LIGHTING FIXTURE REVISIONS; Rev: 7.25.14

Electrical Lighting Plan

A New Residence for:

**Mr. & Mrs. John & Julie Tomlin**

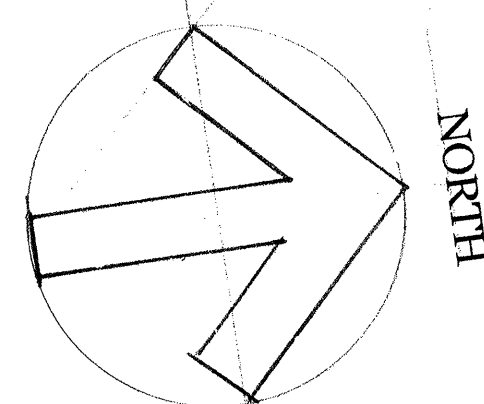
1. Move Wall Sconces in Entry to be 8" o.c. from opening into Living room.
2. Wall Sconces in Living to be 6" o.c. from rough opening of Exterior French Doors.

3. Wall Sconces just inside Living, adjacent to 10' wide arch to be centered on wall segments.
4. At West Bedroom Hallway, provide two (2) Cree ESA-ADR-4-14-LWW-WF-12-27K, wall washers to be aimed at north 8'-6" wall segment, o.c. with eye level, i.e. 5'-6" height + or -. Control with a Dimmer.

5. Center Entry light fixture between truss and wall to the Living room.
6. Note Change in location of Door No. 15 from Hallway to Bedroom 3.
7. 6" recessed light fixture removed from end of hallway outside Bedroom 3.

8. Three (3) ceiling mounted light fixtures replace four (4) wall mounted light fixtures in west bedroom Hallway.
9. Game room, mount Pool Table ceiling light fixture 9'-2-1/2" from north wall finish, and 6'-3" from east wall finish.

10. At Dining room, provide two (2) ceiling mounted lighting fixtures over Dining room table to be 6'-0" o.c. in center of Dining room.

11. Provide three (3) lighting fixtures over Kitchen Island at 2'-6" o.c. ceiling mounted, centered over the island.
12. At Hallway to Garage, one ceiling mounted light fixture replaces two ceiling recessed fixtures.
13. At Hallway to Bedroom 4, one ceiling mounted light fixture replaces one wall mounted light fixture.
14. All Dimmers shall support LED type lighting fixtures, even if those fixtures were originally designed to be lamped with incandescent bulbs.
15. Add Recessed light fixture in Laundry over sink.

16. Relocate Fountain from the entry court out to the driveway, centered on the entry. See Sheet No.11 for dimension to the building. Provide 1 inch diameter sch. 80 conduit with power for lighting and small pump at the fountain.
17. Provide additional recessed light fixture at Bath 5.
18. At Laundry, omit under cabinet light fixture over washer and dryer.
19. Provide an additional recessed light fixture in Pantry.
20. At A/V Equipment cabinets in Family room, omit under cabinet light fixture.
21. At Dining room, omit one of the wall mounted light fixtures on north wall.
22. Omit light fixtures at south patio, but retain switching leg with 3/4 inch conduit to edge of Verandah.
23. Omit one ceiling recessed light fixture at the Office.
24. Omit wall mounted light fixture at south wall M.Bath WC.
25. Omit wall mounted light fixture at west wall Bath 3.

26. See Site Plan Sheet No. 2 for the location of Driveway lights and provide switched leg for two (2) Driveway Entry light fixtures ( same circuit as driveway lights), and power for Entry Gate.
